1. INTRODUCTION

This instruction sheet covers the installation procedures for AMP 110Connect Enhanced 12 Port Modular Universal Wiring Patch Panels. The panel (with bracket) may be mounted directly to a wall or a flat surface using hardware supplied by the installer.

Figure 1

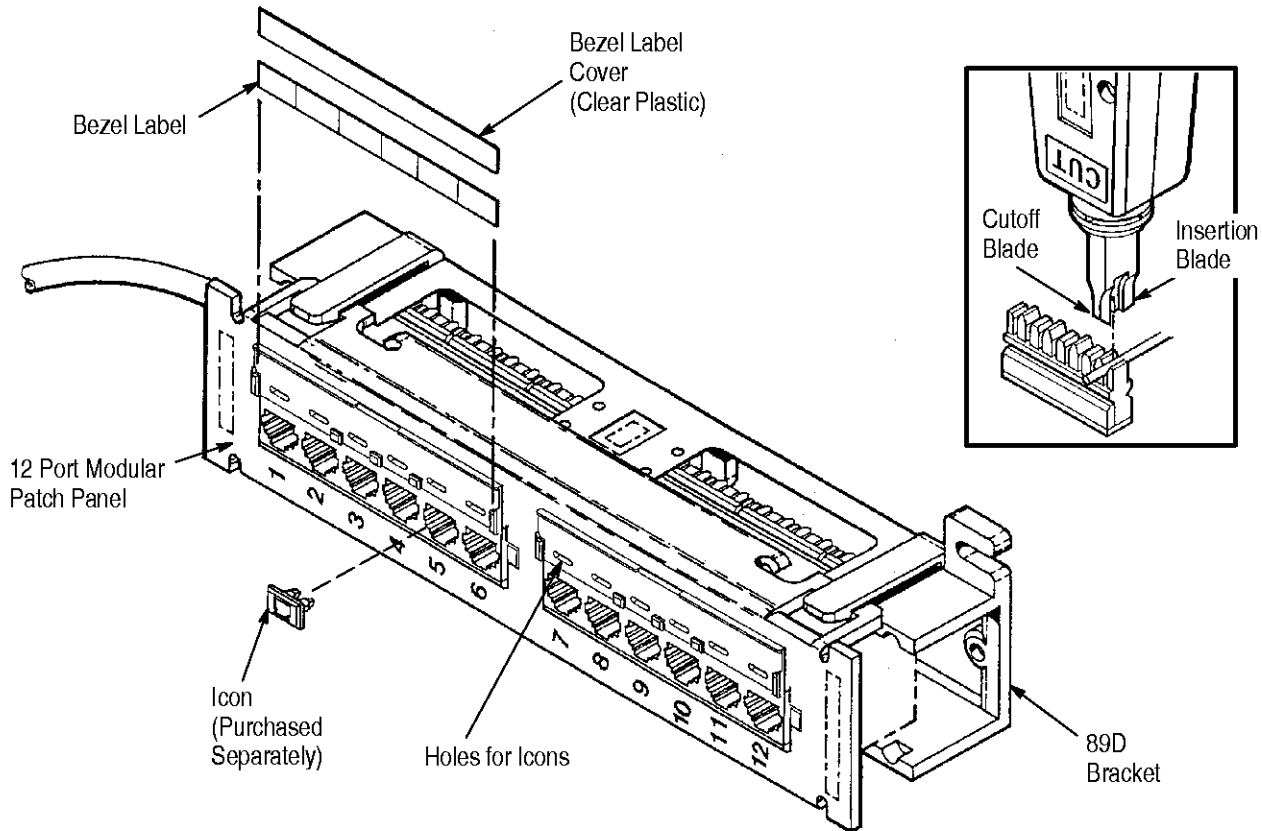
- Removed optional front label kit information and illustration from Figure 1
- Changed illustration of bezel label and added bezel label cover in Figure 1
- Changed illustration of housing in Figure 1
- Added bezel label covers in DESCRIPTION
- Added Section 5, REVISION SUMMARY
